SERVICE BULLETIN

MITSUBISHI MOTORS

PURPOSE : CHANGE	ISSUE NO. : MSB-15EXML11-001	DATE : 2015-09-01
SUBJECT : Setting of the special tool MB992922(Valve stem seal installer adjustable)		<DESTINATION/MODEL> (As shown below) <M/Y> ALL
GROUP : Gr:11(Engine)

Valve stem seal installer
adjustable（MB992922）

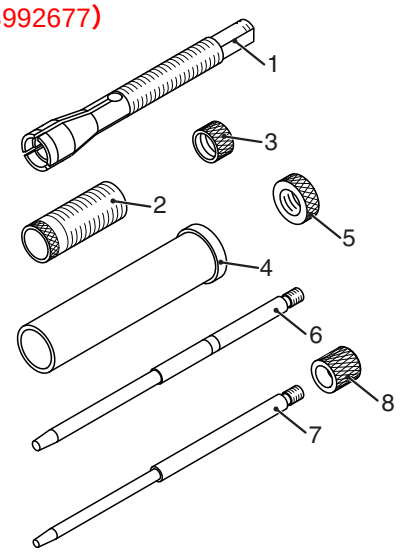
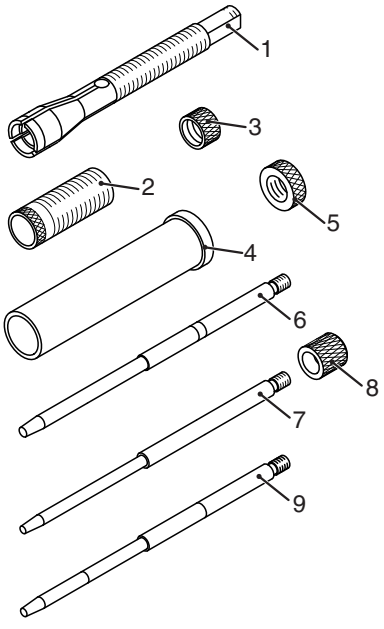
Please refer to the attached document for the information about the change of mention in the applicable service manual. The special tool MB992922(Valve stem seal installer adjustable), which includes MB992677(Valve seal installer adjustable) and MB992855(Guide pin 5.4), is newly set. By this change, the supply of MB992677 is stopped.

1: Chuck
2: Sleeve
3: Lock nut (small)
4: Outer pipe
5: Lock nut (large)
6: Guide pin (5.9)
7: Guide pin (4.9)
8: Cap

1: Chuck
2: Sleeve
3: Lock nut (small)
4: Outer pipe
5: Lock nut (large)
6: Guide pin (5.9)
7: Guide pin (4.9)
8: Cap
9: Guide pin (5.4)
